STAFF REPORT
COMMUNITY DEVELOPMENT DEPARTMENT

HEARING DATE: April 13, 2021

SUBJECT: H-2020-0074
TM Center - PP
Ten Mile Crossing – MDA, RZ

STREET SECTION: S. WAYFINDER AVE.

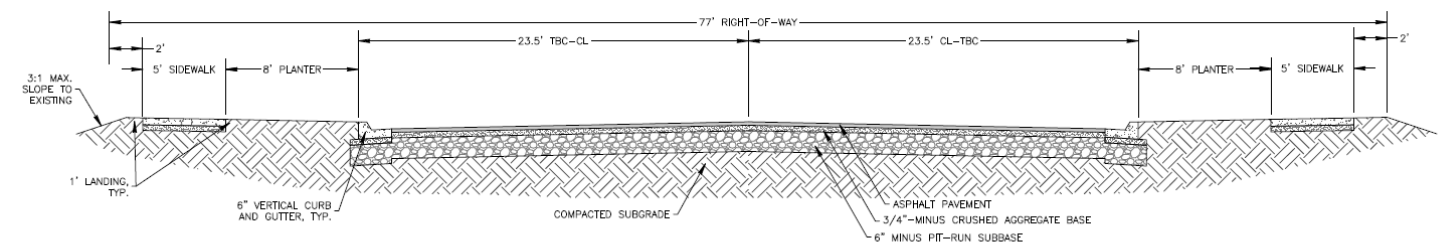
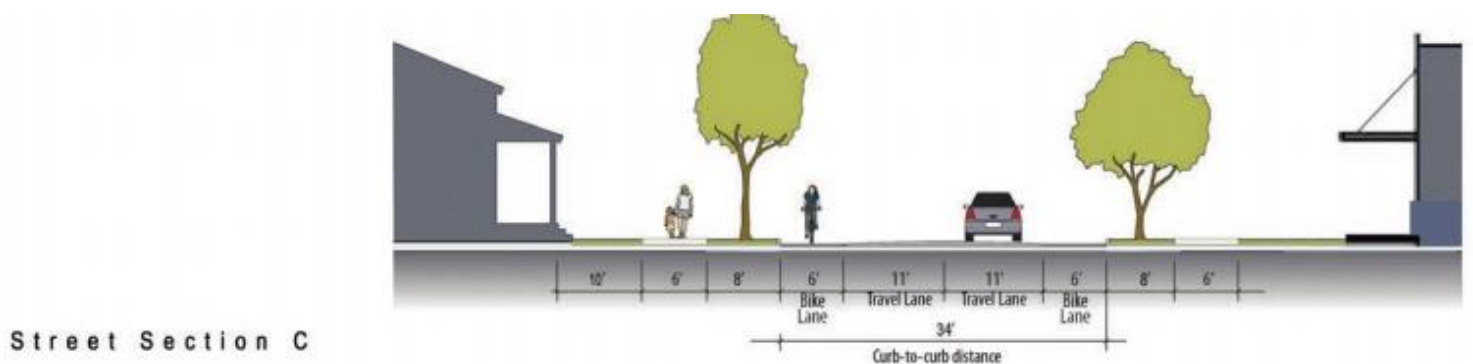
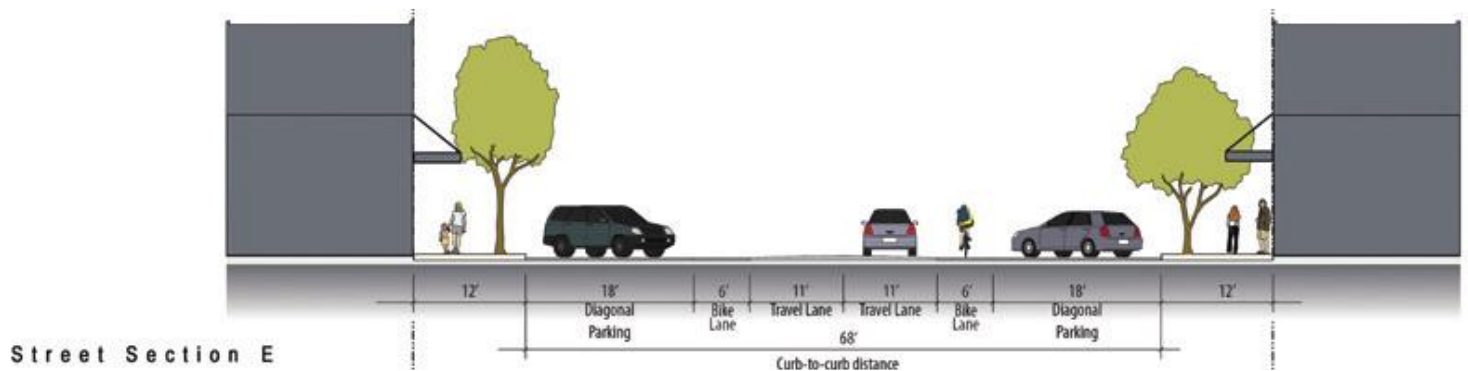
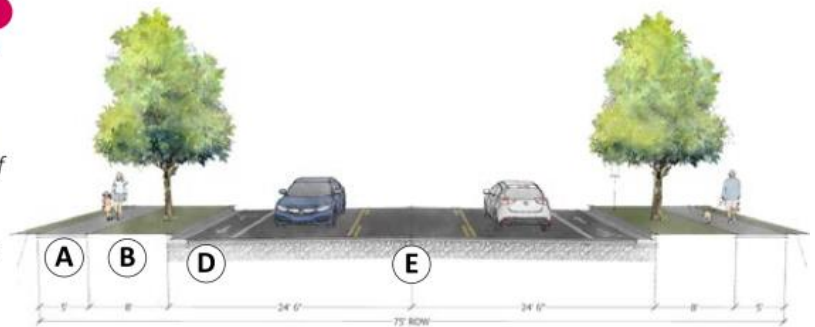
The western north/south collector street, proposed as S. Wayfinder Ave., designated as “E” (minor collector street), extends from a future signalized intersection at W. Franklin Road to the south to Vanguard. The portion north of Cobalt was approved with TM Creek subdivision. **Per the Map and as required by the existing DA for Ten Mile Center, this street should have been constructed per the guidelines for Street Section E shown below with two (2) travel lanes, bike lanes, diagonal parking and 12' sidewalks with trees in wells (see pgs. 3-21 & 3-23 in the TMISAP).** However, the street section approved by ACHD and constructed is a standard street section with (2) travel lanes, a center turn lane, bike lanes, 8-foot wide planter strips, a 5-foot wide detached sidewalk on the west side and an 8-foot wide pathway on the east side with no on-street parking, similar to that of major collector street (i.e. Street Section C, shown below) (see street section from the proposed plat and detail from the proposed design guidelines below). Because of the changes to the FLUM in this area from LC to Commercial and this street providing access to the employment uses to the south, which will likely result in a higher traffic volumes, Staff is in general support of the design as constructed. Minor collector streets in the Plan differ from the MSM's town center collector street in that they don't have a center turn lane and have diagonal instead of parallel parking.

Minor collector streets serve as the primary retail streets and are pedestrian-oriented and defined by street-level storefronts. Buildings are built to 12-foot wide sidewalks with street trees in wells and

pedestrian-scale lighting. A 5-foot wide dry-utilities corridor should be provided along both sides of the street curb; both wet utilities may be located in the street; and streetlights should be placed in the dry utilities corridor on either side of the street.

STREET SECTION: S. NEW MARKET AVE.

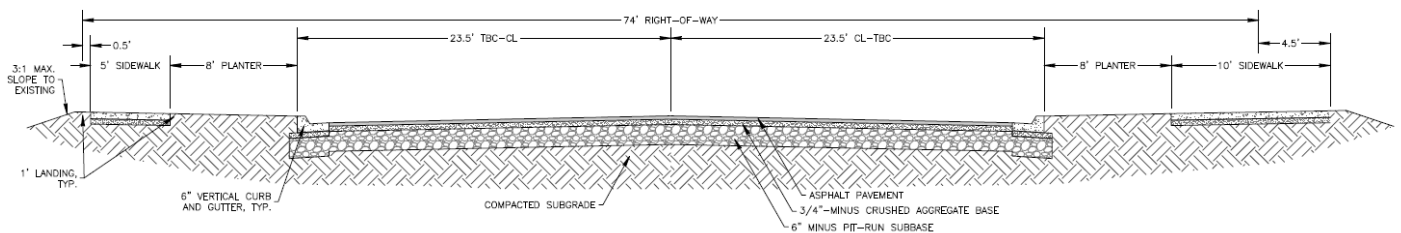
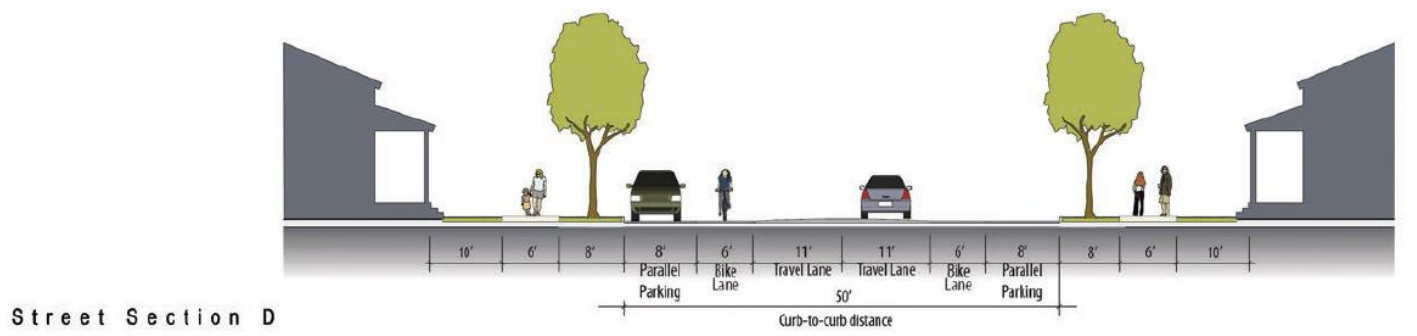
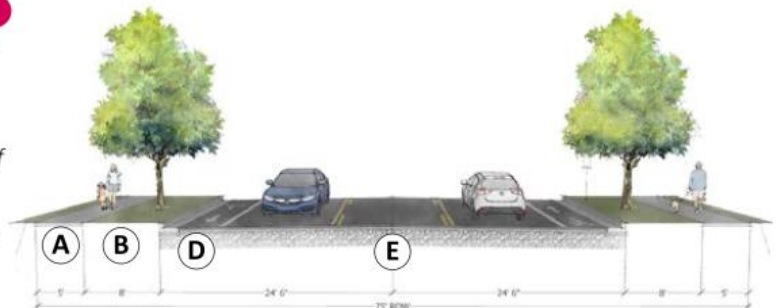
The eastern north/south collector street proposed as S. New Market Ave./Benchmark Ave., designated as “D” (residential collector street), will extend from Franklin Rd. to the south boundary of the site and connect to Navigator Dr. in the TM Crossing project. **This street should be constructed in accord with the guidelines for Street Section D shown below with two (2) travel lanes, bike lanes, parallel on-street parking (if allowed by ACHD), 8’ tree-lined parkways and detached sidewalks per the TMISAP and as required by the existing DA’s for Ten Mile Center and Calnon (see pgs. 3-21 & 3-23 in the TMISAP).**

The street section from the proposed plat and a detail from the proposed design guidelines shown below differ from a residential collector street in that there is a center turn lane, wider travel lanes and no on-street parking. ACHD has approved the proposed design; however, Staff does *not* support the proposed design as it’s not consistent with the TMISAP and the existing DA’s and therefore, recommends revisions consistent with Street Section D below with on-street parking. ACHD will have to review and approve revised street sections if changes are required to the proposed design – although on-street parking is desired and recommended, ACHD will need to review and determine if it’s safe to provide. *Staff discussed the discrepancies between the proposed plat and the town center collector in the MSM and Street Section D with ACHD and was told that although the Livable Street Design Guide allows for parking on a collector street it isn’t always appropriate in all locations – because we don’t know the end users for lots adjacent to these streets (a conceptual development plan or use plan wasn’t submitted) it’s difficult to determine if on-street parking will be appropriate. Residential collector streets in the Plan differ from the MSM’s town center collector street in that they don’t have a center turn lane and have a wider buffer zone.*

- d. South New Market Ave./Benchmark Ave. shall be constructed with two (2) travel lanes, bike lanes, parallel parking (if allowed by ACHD), 8-foot wide parkways and detached sidewalks/pathways consistent with Street Section D in the TMISAP, the development agreement, Pathways Master Plan and pathway plan for the site. *The first 200' of south of Franklin Rd. on New Market is not allowed to have on-street parking per the ACHD report to allow for right and left turn lanes.*

- b. Depict a minimum 5-foot wide detached sidewalk along the west side of S. New Market Ave./Benchmark Ave. where 8- to 10-wide pathways are not proposed on the pathway plan, with 8-foot wide parkways within a minimum 20-foot wide landscaped buffer in accord with the TMISAP for Street Section D (see pg. 3-21).

STREET SECTION: W. COBALT DR.

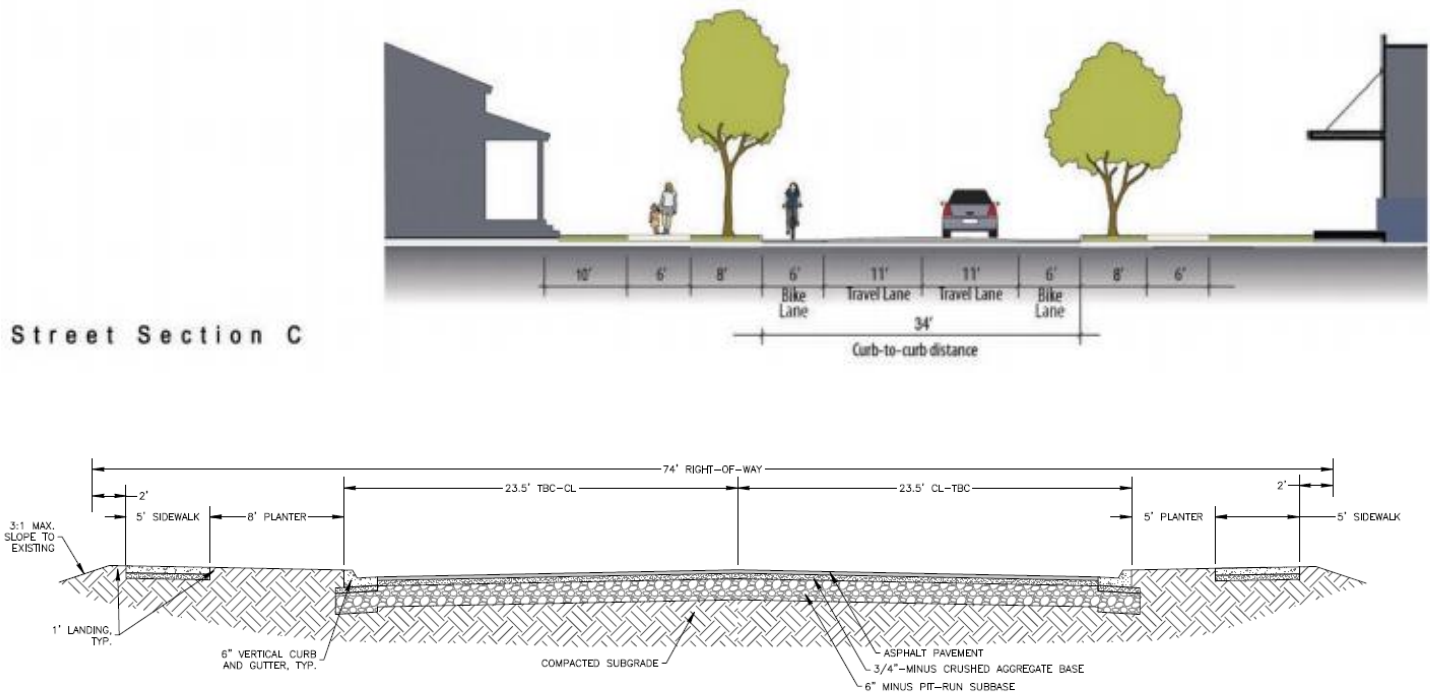
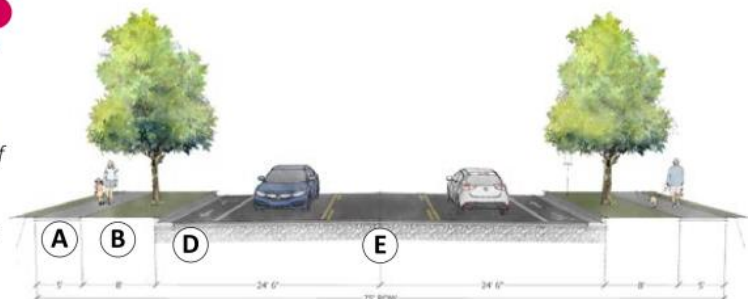
Neither the SSM shown above, nor the MSM, depicts an east/west collector where W. Cobalt Dr. is proposed to extend between Wayfinder and New Market although it does depict such further to the south in alignment with the access via Ten Mile Rd. along the southern boundary of this site which was actually constructed further to the south (i.e. Navigator Dr.) as discussed above. This southern section is designated as a minor collector street ("E") on the Street Section Map in the TMISAP and as a town center collector on the MSM. The portion of Cobalt west of Wayfinder is designated as a residential collector street (Street Section D) but was approved to be constructed as a major collector street closely aligning with Street Section C due to residential uses not being planned at that time in that area – since that time, the development plan changed and multi-family residential uses have been constructed along the north side of the street, east of S. Innovation Ln.

The extension of Cobalt will provide a connection from Ten Mile between Wayfinder and New Market/Benchmark, which Staff believes provides much needed connectivity in this area. Residential

uses exist and are planned on the north side of this street between Wayfinder and New Market/Benchmark with future commercial uses likely on the south side. The section of this street east of TM Creek East Apartments has not yet been constructed but the design has been approved by ACHD with the subject plat. Staff is amenable to the proposed design consistent with that constructed to the west.

Street Section C, the street section from the plat and a detail from the proposed design guidelines are shown below. The western portion of Cobalt in front of the TM Creek East apartments project was previously approved as part of ACHD's action on that project and has been constructed.

- c. Depict a minimum 20-foot wide street buffer, landscaped per the standards listed in UDC 11-3B-7C, along each side of W. Cobalt Dr., a collector street; and a detached 8- to 10-foot wide pathway on the south side of the street consistent with the pathway plan.

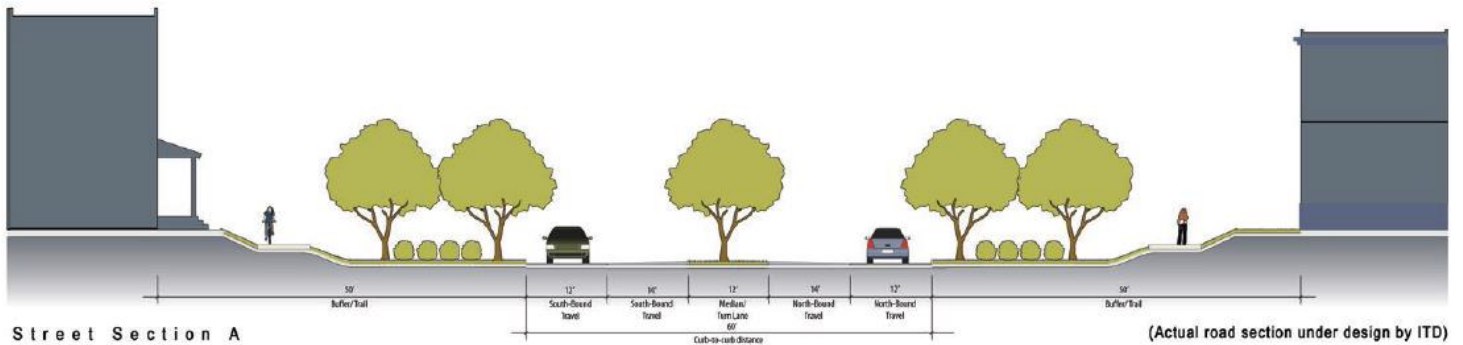
South Ten Mile Rd., an existing arterial street along the west boundary of the site, is designated as a modified 4-lane parkway (“A”) on the Street Section Map. **Buildings should address the street but be set back some distance from the roadway to provide security to the pedestrians and bikes and a wide tree lawn and detached trail should be provided as shown on Street Section A below. Streetlights should be located in the tree lawn area and should be of a pedestrian scale. Dry utilities should be located back of the curb in the dry utilities corridor.**

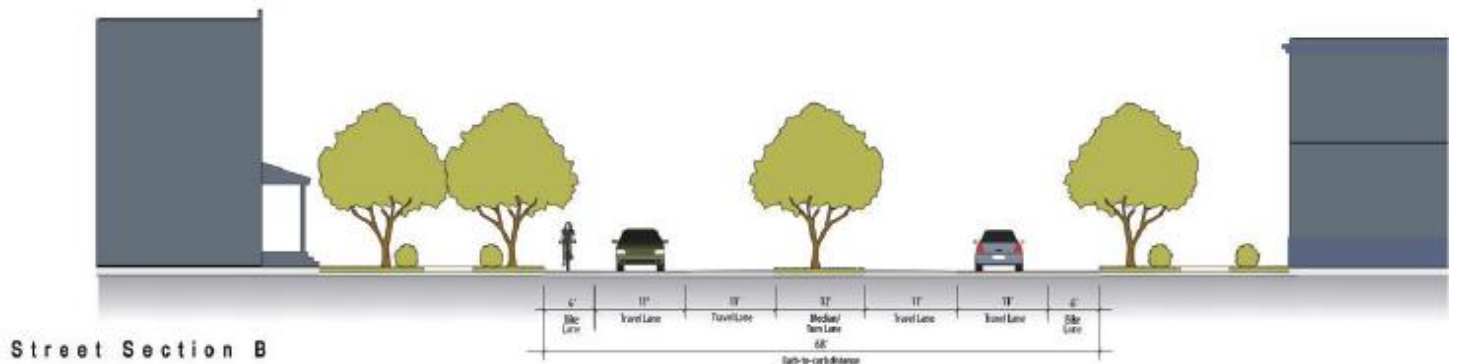
West Franklin Rd., an existing arterial street along the north boundary of the site, is designated as a typical 4-lane parkway (“B”) on the Street Section Map. **Buildings should address the street but be set back some distance from the roadway edge to provide for a tree lawn and detached sidewalk to provide security to the pedestrian as shown on Street Section B below. Streetlights should be located in the tree lawn area and be of a pedestrian scale. Dry utilities should be located back of the curb in the dry utilities corridor.**

- (9) Street lights at a pedestrian scale shall be installed within the tree lawn area along W. Franklin Rd. as set forth in the TMISAP.
 - (10) The Applicant should follow the bubble plan concept presented at the hearing as they move forward with their conceptual development plans.
